Intel[®] 80303 and 80302 I/O Processors

Specification Update

May 6, 2003

Order Number: **273355-010**

2. Figure 9-3 on pg 9-9 did not print correctly

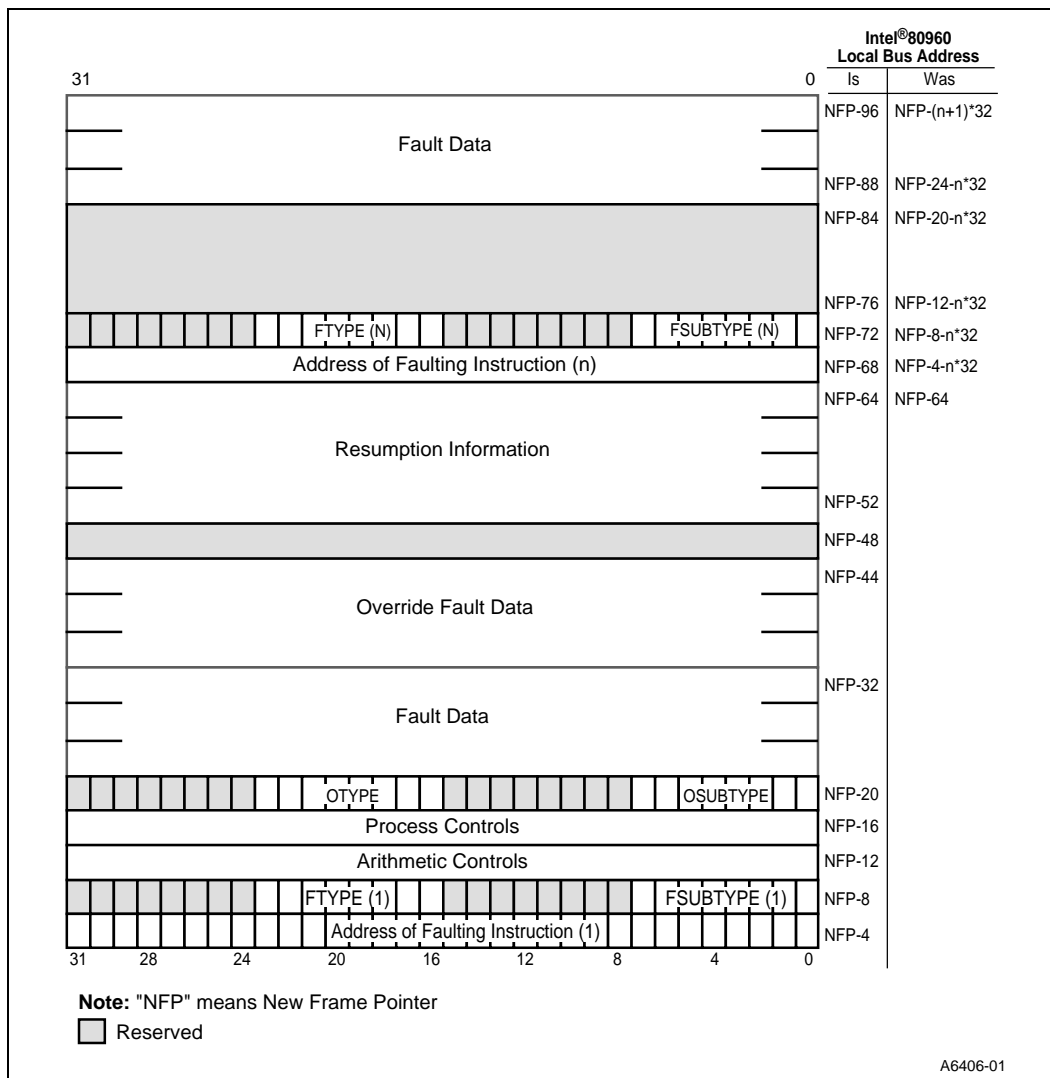
Problem: Figure 9-3 on pg 9-9 did not print correctly.

Workaround: Replace Figure 9-3 with the following:

3. Figure 13-22 on pg 13-40 did not print correctly

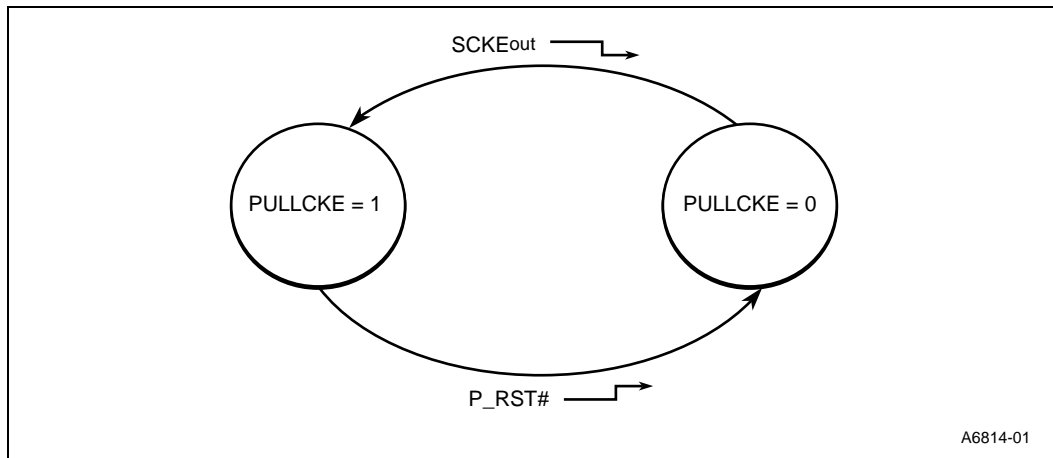
Problem: Figure 13-22 on pg 13-40 did not print correctly.

Workaround: Replace Figure 13-22 with the following:

4. Figure 13-18, pg 13-35

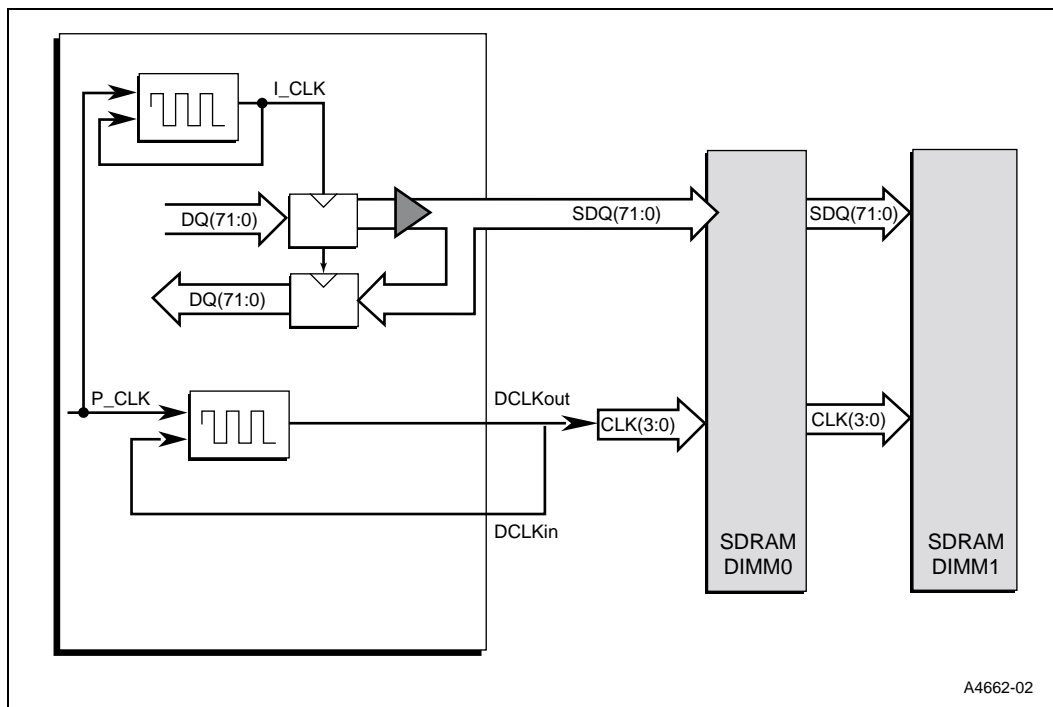
Problem: Replace Figure 13-18 with the following:

5. **Figure 15-2 on pg 15-3 did not print correctly**

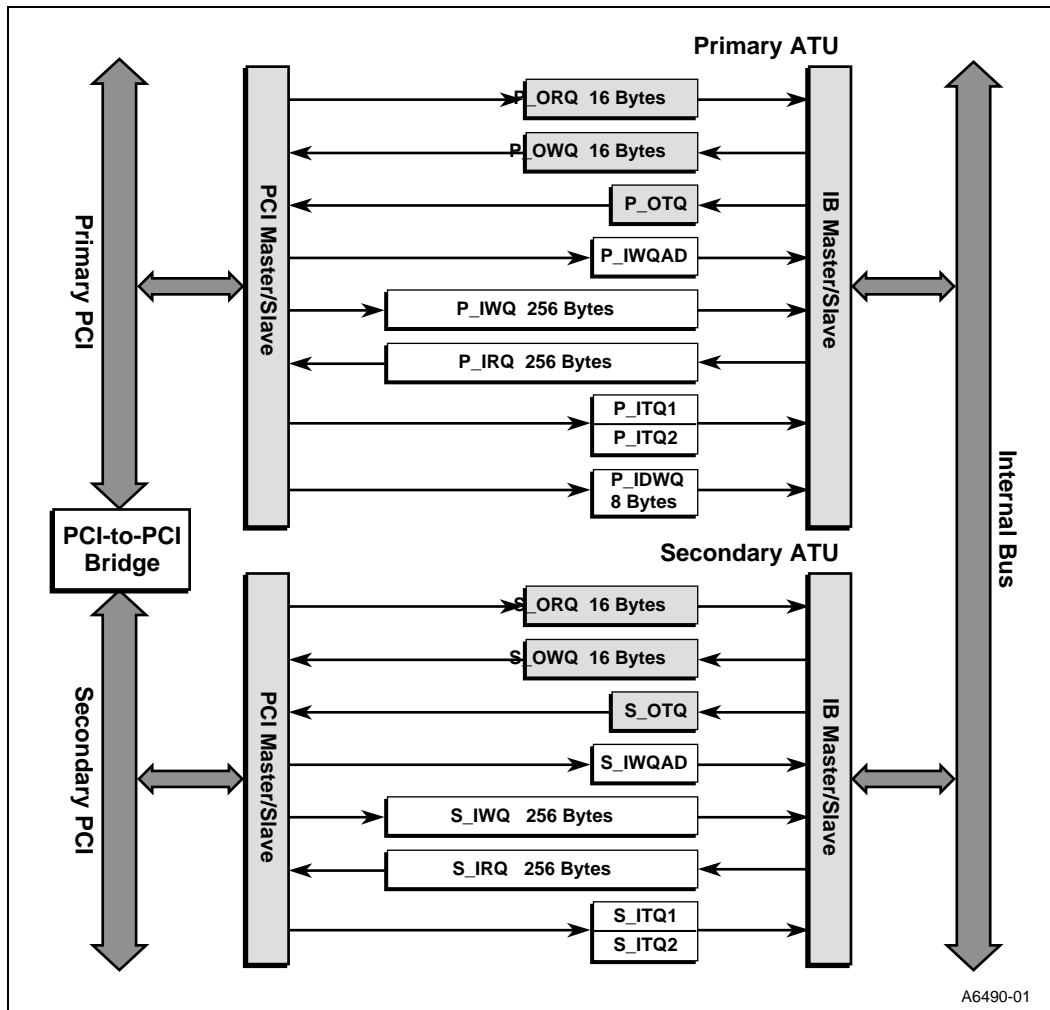
Problem: Figure 15-2 on pg 15-3 did not print correctly.

Workaround: Replace Figure 15-2 with the following:

Figure 25-1. Intel® 80303 I/O Processor Clocking Regions Diagram

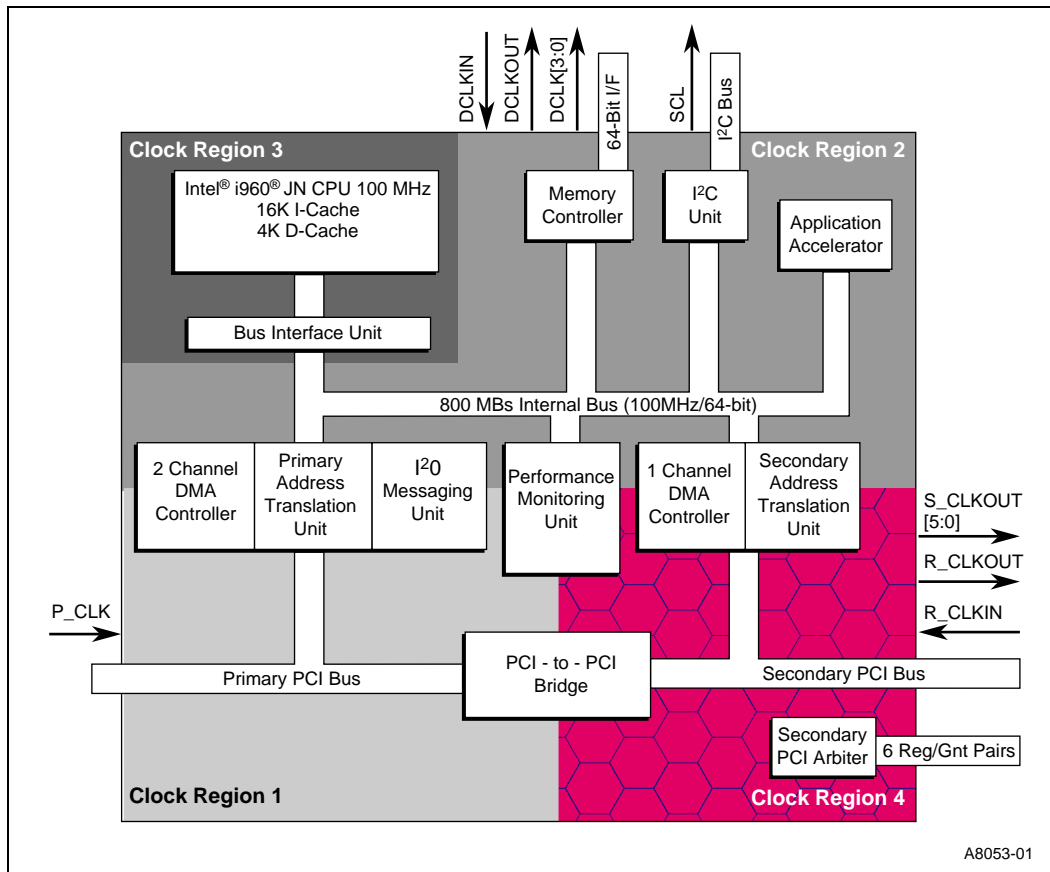
Problem: The Internal bus in diagram shows 66 MHz bus speed. The actual bus speed is 100 MHz

Workaround: Replace Figure 25-1 with the following:

11. Figure 25-2 on pg 25-2 did not print correctly

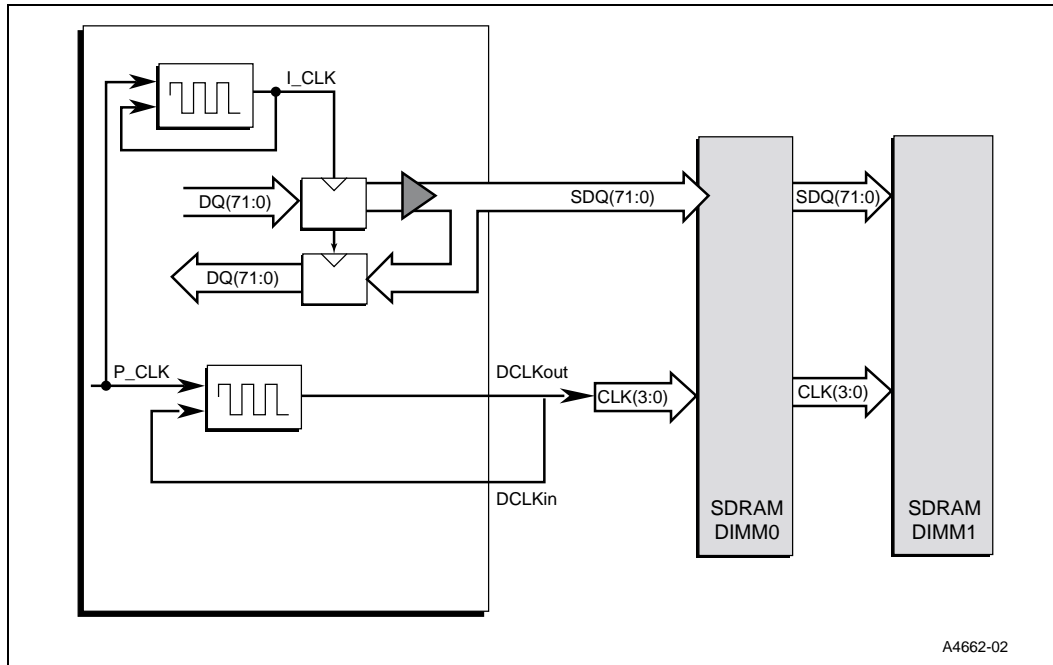
Problem: Figure 25-2 on pg 25-2 did not print correctly.

Workaround: Replace Figure 25-2 with the following:

Figure 12-2. Core Processor/BIU Interface Block Diagram

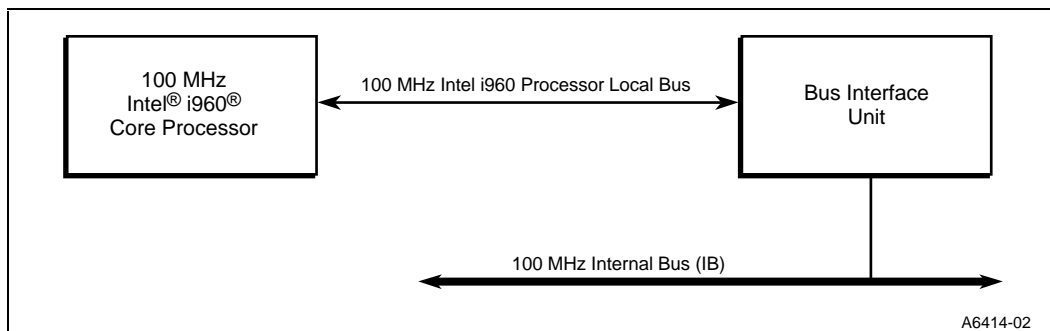
Problem: The Internal bus in diagram shows 66 MHz bus speed. The actual bus speed is 100 MHz

Workaround: Replace Figure 12-2 with the following:

18. Figure 15-3 on page 15-7 has missing text

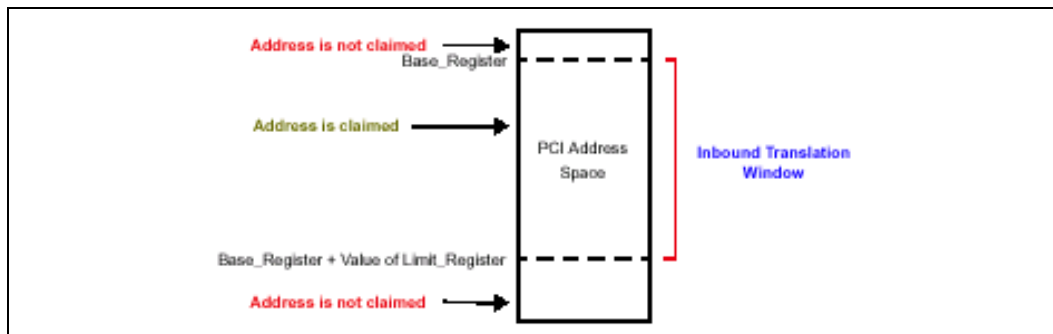
Problem: The figure shows 'se_Register + Value of Limit_Register'. It should be 'Base_Register + Value of Limit_Register'.

Workaround: Replace Figure 15-3 with the following:

Figure 13-16. ECC Read Data Flow

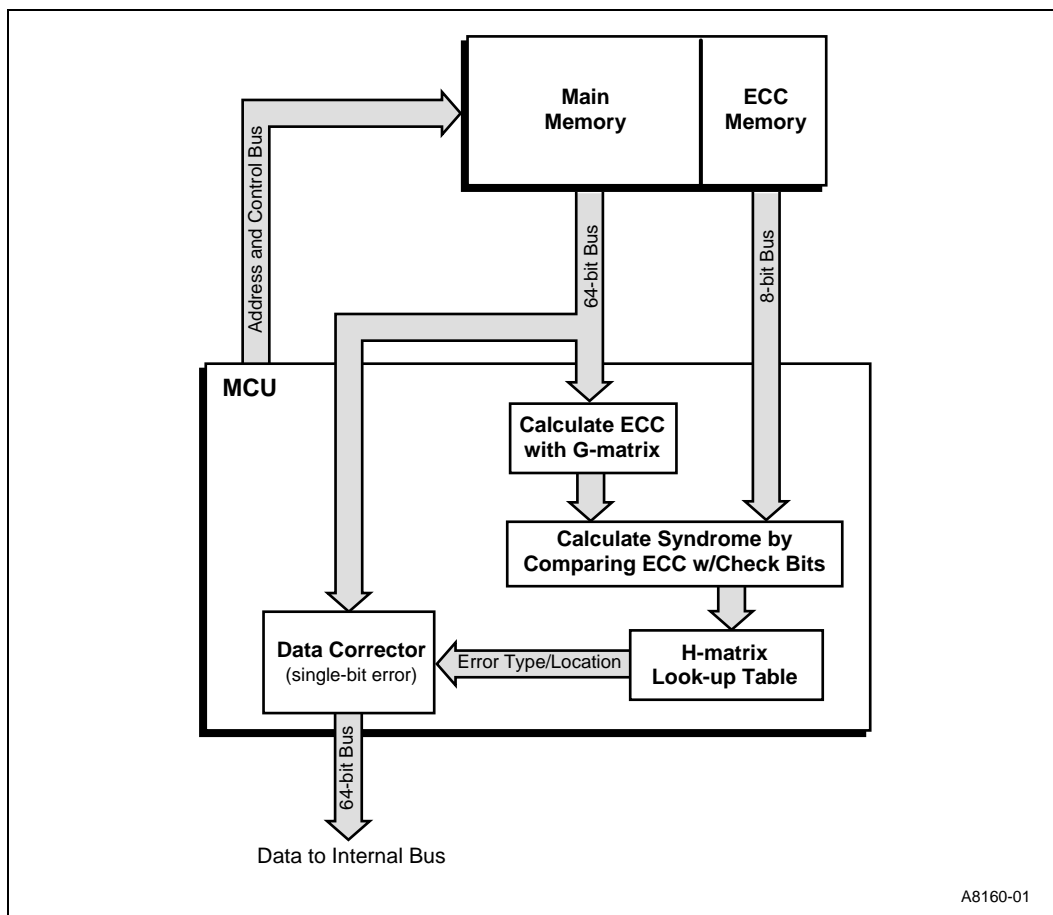
Workaround: Replace Table 13-13 with the following and, add the adjacent paragraph with “new” Figure 13-16:

Figure 13-16 shows how the data flows through the ECC hardware for a read transaction.
